Selina Poyner
27 Rosalind Street
Cammeray NSW 2062
1 April 2026

Submission: Formal objection to the Cammeray Seniors Living development (SSD-96505456)

Image 3: EIS flawed solar analysis, highlighting correct height of hedge and underlying timber fence

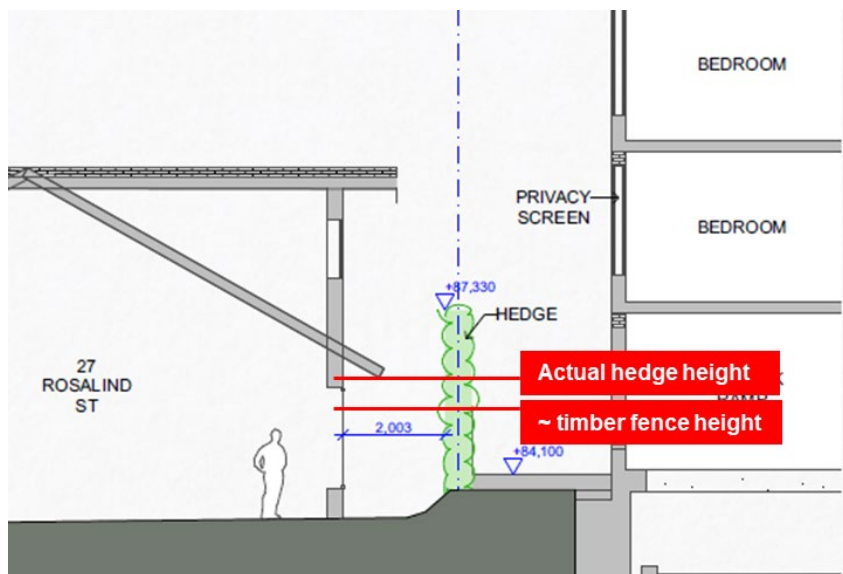
The EIS also misrepresents the hedge’s height and disregards the fixed timber fence beneath it (~ 0.5 m lower). Based on the section drawings, the hedge height assumed appears overstated by more than 75% when compared with the underlying timber fence. See Images 4 and 5 for the current height of the hedge and the underlying timber fence. The hedge does not extend almost to the bottom of the upper-level windows, as depicted in Image 3.

The hedge is routinely cut back in winter to maximise sunlight and allowed to grow higher in summer for shade. It was at its maximum height when the solar assessment was prepared. It also sits on a failing retaining wall that requires replacement and is not addressed in the EIS, further undermining the assessment’s reliability.

Image 6: EIS assessment of neighbouring primary living space and landscape zones

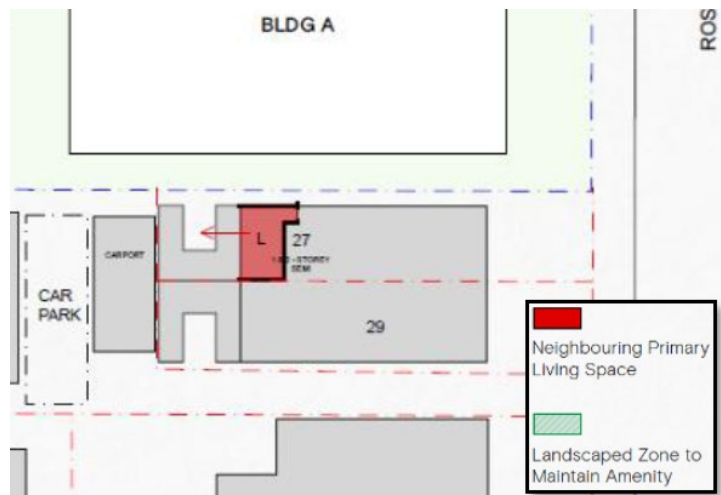
The EIS does not correctly identify the main living spaces in my home and overlooks or downplays those that it does identify. Its discussion of impacts on 27 Rosalind Street relies heavily on a single window to a “secondary living space”, said to be partially shaded by boundary vegetation, and then extrapolates from that limited reference point to conclude that overall amenity impacts are minor.

While the EIS identifies the kitchen and dining area as part of the home’s primary living environment, it provides no further analysis of this space or of the attached rear courtyard. The courtyard is integral to the amenity of the kitchen and dining area, as it is directly connected via full-height glass bi-fold doors and serves as the primary source of ambient and reflected daylight to that part of the home.

Image 6 illustrates the EIS’s limited identification of living spaces and does not show the proposed landscaped zone along the eastern boundary referenced elsewhere in the EIS documentation.

Image 8: Shadow diagrams 1/2 (Appendix A, EIS), showing assessed solar impact on 27R at 1 pm

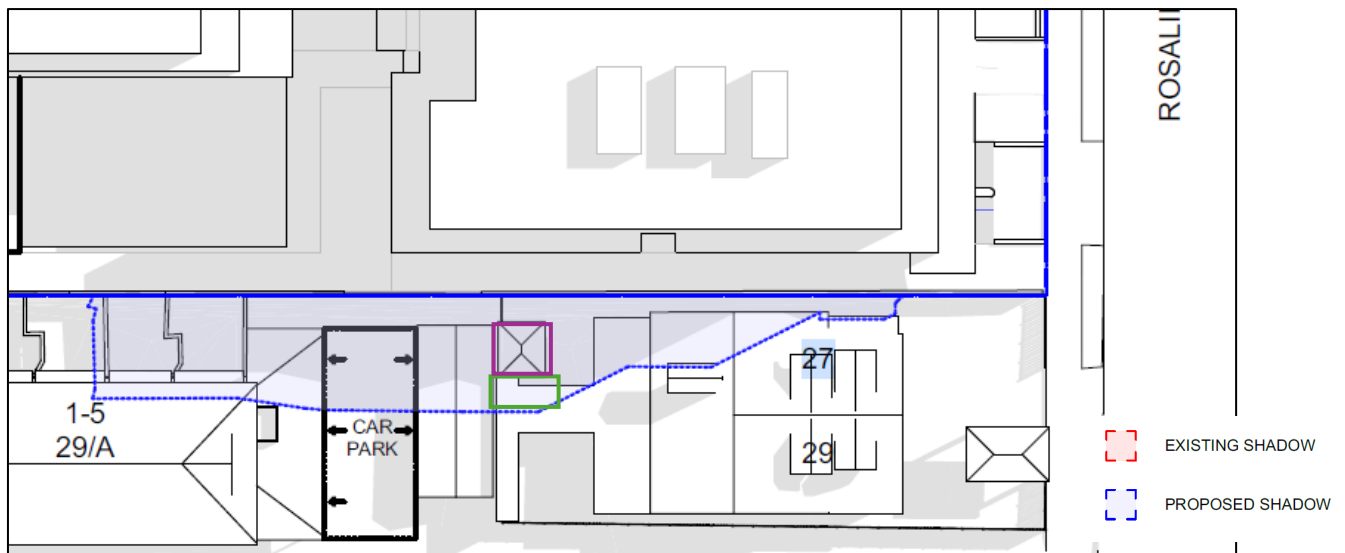
When compared with the proposed shadow extent shown in Image 8 from the EIS, these photographs illustrate that the development would place all west-facing windows into complete shadow before 1 pm, well before the times currently experienced. This would result in a substantial and unjustified loss of solar access post-development.

Observations on Image 8:

- The image does not include a pink dashed line on my property to denote existing shadow. On this basis, it appears the grey shading represents the proponent's assessment of existing shadow extent.
- The structure shown in purple is an outdoor cabana or sunroom. It is a well-used private outdoor space that currently receives direct sunlight until late afternoon.
- The EIS appears to overstate built structures within my rear courtyard along the eastern boundary, as marked by the green rectangle. This area is garden space, not built form.

Image 9: Aerial panorama photograph, 22 July at 1:46 pm (shadow conditions are effectively equivalent to those on 21 June at 1:00 pm, with the shadow length an immaterial ~1% longer in this image)

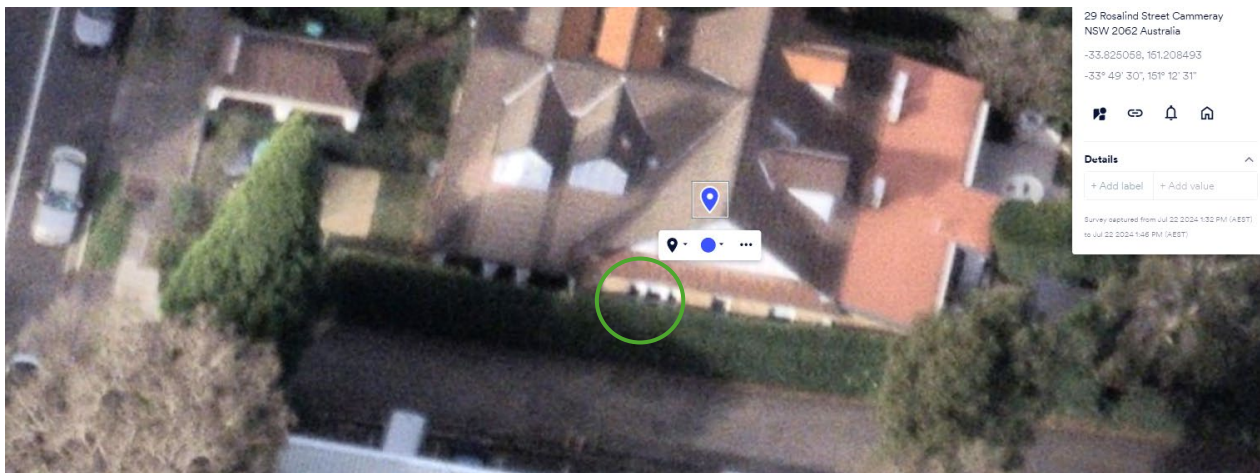
- **Both house levels currently receive direct sunlight.** The upper level is sunlit, as is the lower level from the front door through to the rear, including the living area identified in the EIS as a “secondary” space (shown by the green circle). See Image 11 for sunlight conditions in the rear courtyard.

Image 10: Aerial panorama photograph showing existing solar conditions, 23 May at 12:19 pm

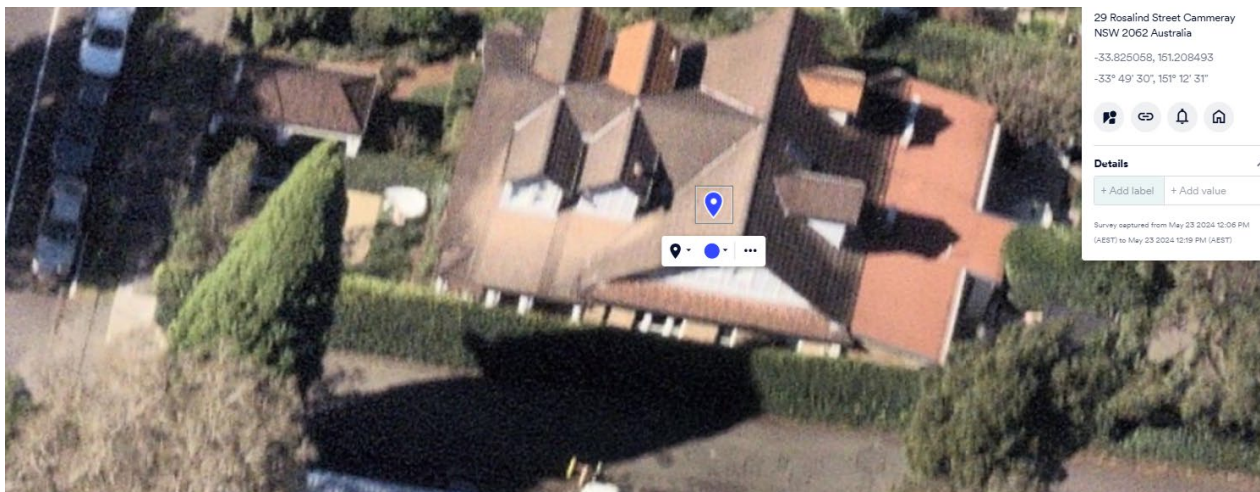
- The image above further confirms that the entire home, including both upper and lower levels, currently receive direct sunlight.

Image 11: Aerial photograph showing existing solar conditions, 20 June at 1:48 pm (48 mins later than EIS)

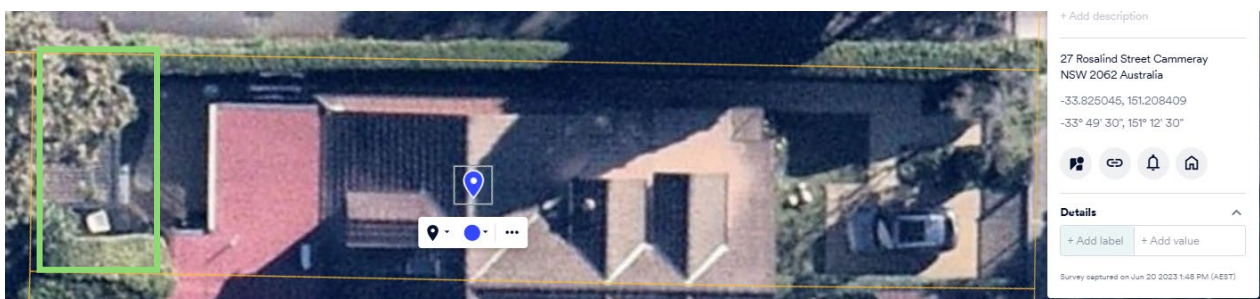
- The image above, taken almost an hour later than the EIS solar assessment, demonstrates that existing solar access is materially greater than represented in the EIS, with more than 50% of the rear courtyard remaining in direct sunlight.

Side of 27 Rosalind Street (eastern boundary) – 23 March 4.30 pm

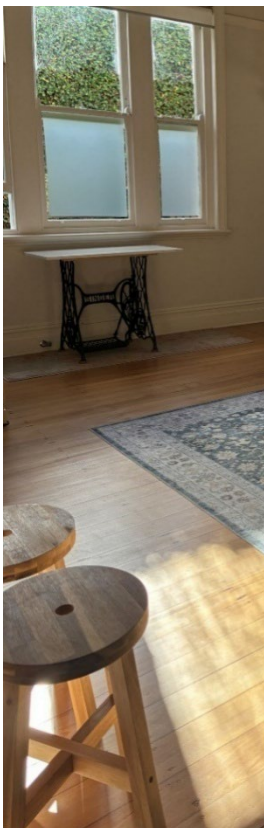
- Upper level remains in full sun; north façade is still partly sunlit.
- Under the proposal, this would be in full shadow.
- Western façade still enjoying sunlight including front balcony
- Under the proposal, northern solar access would also reduce because Building A extends further north than my house

Rear of 27 Rosalind Street – eastern boundary

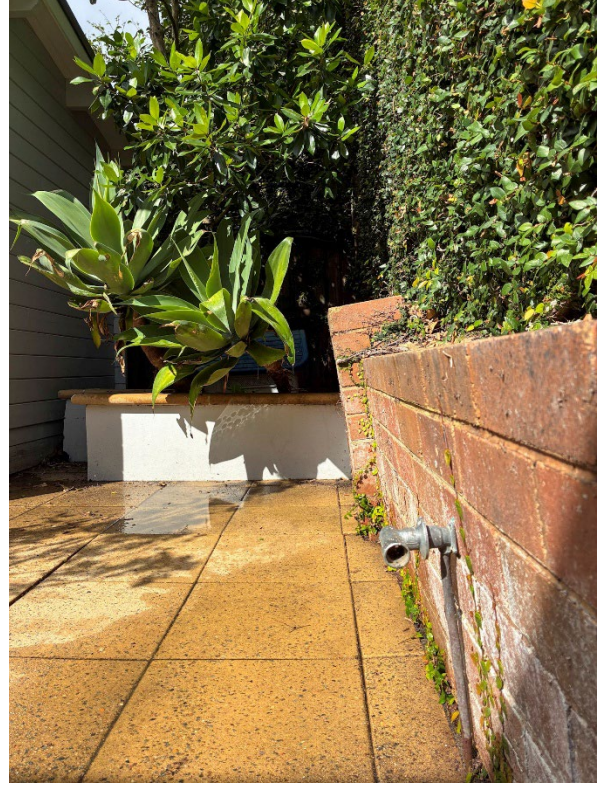
- The hedge is located above the retaining wall on the developer’s land. The structure comprises a brick base, topped with a timber fence, with the hedge growing above.
- The ongoing lean/movement of this retaining wall/fence/hedge structure is visible along the eastern boundary.

5. **Replace the deteriorated eastern boundary retaining wall** supporting the higher ground at 19–23. The wall must be independently assessed, then removed and replaced with a new wall capable of safely supporting the proposed excavation and retained ground levels.

Brick sub-wall at the rear of 27 Rosalind Street (eastern boundary), supporting the developer's retaining wall:

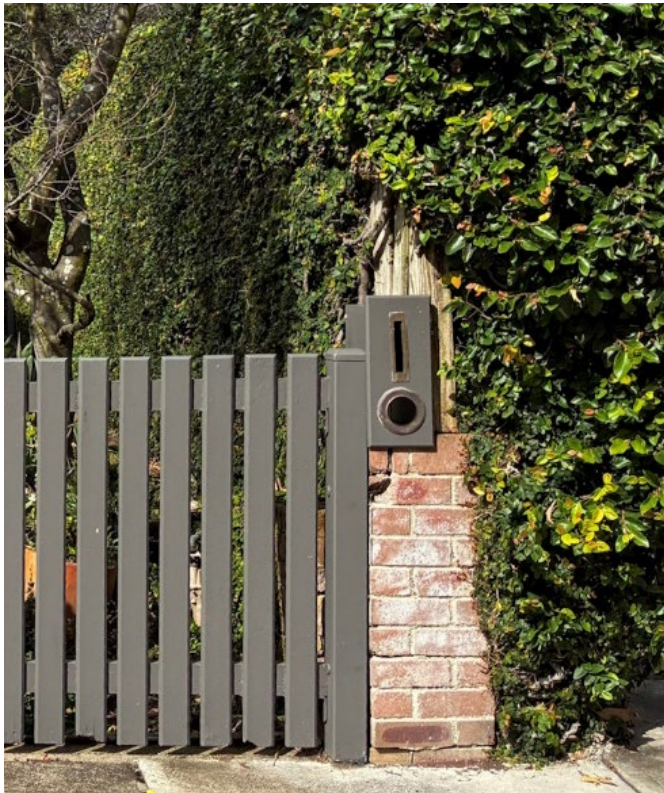
- The brick sub-wall exhibits visible cracking and leaning, consistent with pressure from the failing retaining wall behind it.
- Brick loss, root penetration, and general deterioration are evident along the length of the wall, indicating ongoing instability.
